Access Compliance Report

Public Rights-of-Way

Intersection ID: 15763	Main Street: MONROE_RD	Cross Street: N_WENDOVER_RD	Location: W
ADA ID: EF56537CDF8E	Ramp Type: PerpDiag	Initial Pass/Fail: Fail	Overall Compliance: No
Severity Score: 8.75			
Codes/Mitigation Info/Possible Solution		Field Measurements/Component Compliance

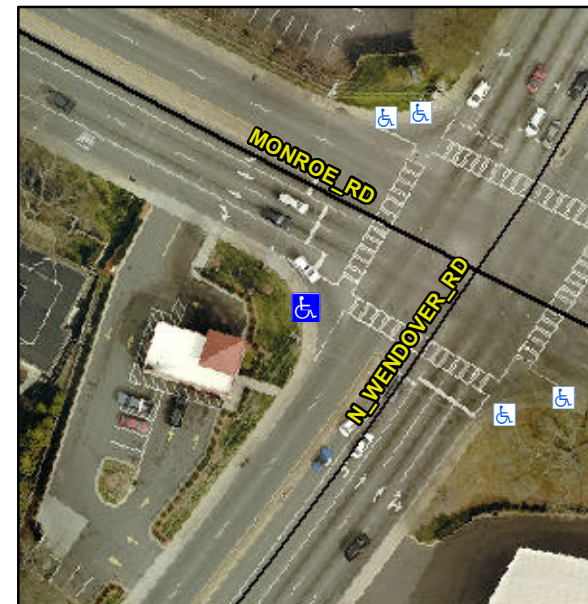
Not Found, R304.5.1

Compliance	Description	Data	Compliance	Description	Data
N/A	Ramp Length (in)	60.0	Yes	Ramp Slope (%)	6.4
No	Ramp Width (in)	41.0	Yes	Ramp XSlope (%)	0.1
N/A	Flare Type LT	N/A	N/A	Flare Type RT	N/A
N/A	Flare Slope LT (%)	N/A	N/A	Flare Slope RT (%)	N/A
N/A	Flare Traversable LT?	N/A	N/A	Flare Traversable RT?	N/A
N/A	Landing Length (in)	N/A	N/A	DWS Provided?	N/A
N/A	Landing Width (in)	N/A	N/A	DWS Contrast?	N/A
N/A	Landing Slope (%)	N/A	N/A	DWS Length (in)	N/A
N/A	Landing X Slope (%)	N/A	N/A	DWS Full Width?	N/A
N/A	Landing Curb? (Y/N)	N/A	N/A	DWS Offset (in)	N/A
N/A	Shared Landing?	N/A			
N/A	Gutter Ponding?	N/A	N/A	Gutter Slope (%)	N/A
N/A	Gutter Lip Ht (in)	N/A	N/A	Gutter X Slope (%)	N/A
N/A	Painted X Walk1?	Yes	N/A	Painted X Walk2?	Yes
	X Walk 1 Direction	To SE		X Walk 2 Direction	To NE
N/A	X Walk 1 Width (in)	107.0	N/A	X Walk 2 Width (in)	107.0
	X Walk 1 Slope (%)	0.9		X Walk 2 Slope (%)	0.6
	X Walk 1 X Slope (%)	0.5		X Walk 2 X Slope (%)	1.0

Remove & Replace Curb Ramp With Two New Directional Ramps or Equivalent. Restripe Crosswalk.
